March 5th, 2019

MCGB/MCGS/MCDB/MCSF port size M5 plug washer material and appearance modification notice

Part name	Before	After
	Plastic material	Rubber material
M5 Plug washer

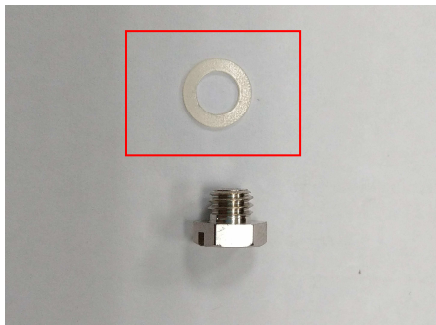
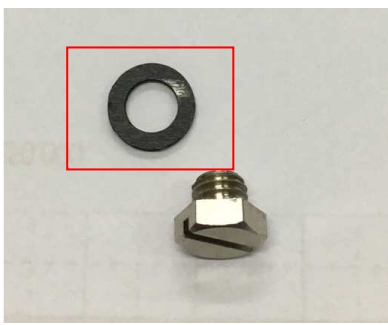
The original white plastic washer with high hardness causes assembly difficulty. To improve the efficiency of assembly, material would be changed to low hardness black rubber.
